**UNITED STATES
NUCLEAR REGULATORY COMMISSION**
REGION II
245 PEACHTREE CENTER AVENUE NE, SUITE 1200
ATLANTA, GEORGIA 30303-1257

**SUBJECT: NUCLEAR REGULATORY COMMISSION AUGMENTED INSPECTION TEAM
REPORT NO. 70-1151/2016-007**

Report No.: 70-1151/2016-007

Facility: Columbia Fuel Fabrication Facility

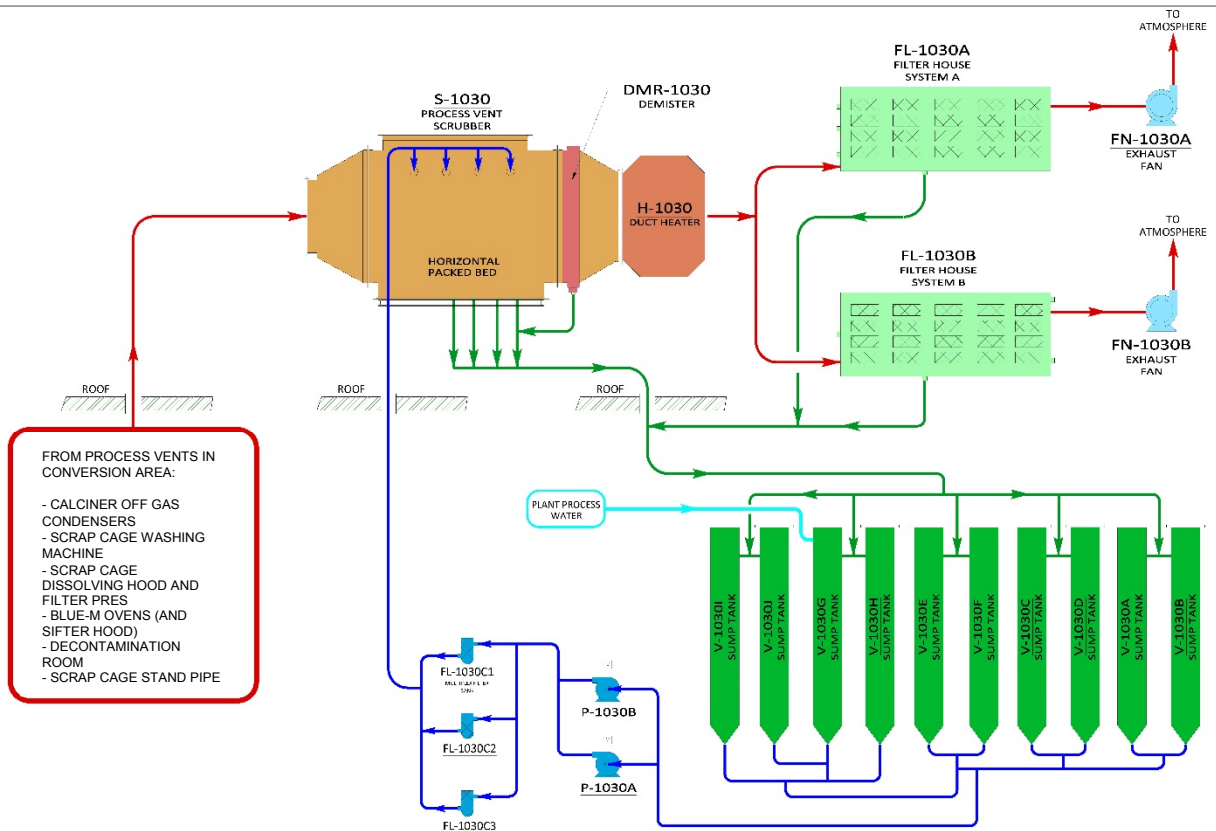
The S-1030 scrubber was installed in 2001, and began operations in 2002. The S-1030 scrubber replaced the S-1056 scrubbing system and combined vents that previously fed scrubbers S-1056 and 3A/B. In 2009, the feed streams that previously fed the 7A scrubber were routed to the S-1030 scrubber. The S-1030 scrubber operates as a cross flow horizontal packed bed scrubber where a recirculating scrubbing liquid is used to absorb soluble gas molecules and knock down suspended solids including uranium bearing particles vented from several processes in the Conversion area. The scrubber was originally designed to scrub acidic off-gas, however, many of the current feed streams contain ammoniated (basic) off-gas. The main process systems that vent to the S-1030 scrubber include: two nitrate storage columns, calciner off-gas scrubber condensers and various vent lines, decontamination room wet cleaning hood, scrap cage dissolver hood and filter press, S-1030 sump tanks, Blu-M Oxidation hoods/sifter enclosures, scrap cage washing machine, flexible hoses for the ADU holding tank, and various drain lines for conversion process equipment.

The feed streams all tie together through a network of duct work of various diameters to a large diameter section before entering the transition into the S-1030 scrubber. The large surface area reduces the linear velocity of the incoming stream as it enters the scrubber body. This speed reduction allows for greater reaction time between the scrubber solution and the incoming streams. The scrubber body contains a specialized packing to increase the surface area of the scrubber liquid. The increase in surface area allows for more absorption of gaseous contaminants into the scrubber liquid. The following diagram provides a visual representation of the S-1030 scrubber and related feed streams; this diagram does not show the inlet spray nozzles.
